PLAN APPROVAL DATE	CONTRACT No.	PROJECT ID	DISTRICT	COUNTY	ROUTE	POST MILES TOTAL PROJECT
	04-0G3501	0400000325	04	SF	1	R0.94/4.05
19TH AVENUE (STATE ROUTE 1) COMBINED CITY PROJECT						
19TH AVENUE AND SANTIAGO STREET						
CONTRACT NO. 1000005832 DRAWING NO. E-10.0 FILE NO. 111,406 REV. NO. 1

REFERENCE INFORMATION & FILE NO. OF SURVEYS				
1	10/28/20	PCO#2 POLE RELOCATION	KS/MA	MY
NO.	DATE	DESCRIPTION	BY	APP.
TABLE OF REVISIONS				
THIS DRAWING WAS LAST MODIFIED: 02/24/21 10:08, BY: Mlung

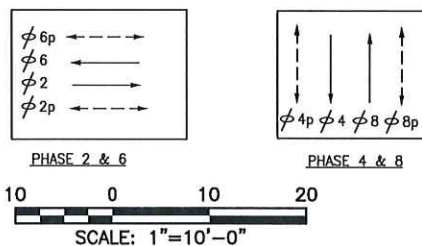
NOTE:
THIS AUTOCAD DRAWING HAS BEEN REVISED AND REPLOTED
SUBSEQUENT TO INTERNAL ENGINEERING APPROVAL AND
SIGN-OFF. FOR THOSE SIGNATURES, SEE THE DRAWING
PLOTTED AND ISSUED PREVIOUSLY DURING BIDDING. THE
SIGNED DRAWING REMAINS VALID EXCEPT FOR THE CHANGES
ONLY AS CLEARLY MARKED ON THIS DRAWING AND ISSUED
UNDER THIS LATEST REVISION NUMBER AS SHOWN IN THE
TABLE OF REVISIONS LOCATED AT THE LOWER LEFT CORNER
OF THE DRAWING. ALL ISSUED REVISIONS SUBSEQUENT TO
PREVIOUSLY PLOTTED DRAWING DURING BIDDING REMAIN
VALID UNLESS SUPERSEDED BY LATER ISSUED REVISIONS.
CHECK ALL ISSUED REVISIONS OF THIS DRAWING.

- 3 CONTRACTOR TO [AB] LOOP DETECTORS. CITY FORCES TO INSTALL WIRELESS SENSYS DETECTORS IN PLACE OF LOOP DETECTORS.
- 4 REUSE AND [RL] EXISTING MAST ARM POLE AS INDICATED BY POLE H ON NEW FOUNDATION. [RL] EXISTING STREET LIGHT FIXTURE. [RC] EXISTING TRAFFIC SIGNAL EQUIPMENT, MOUNTINGS, ASSOCIATED CONDUIT, AND FOUNDATION. PROVIDE NEW TRAFFIC SIGNALS AND MOUNTINGS PER POLE AND EQUIPMENT SCHEDULE. PROVIDE TEMPORARY SIGNAL AND LIGHTING AS REQUIRED.
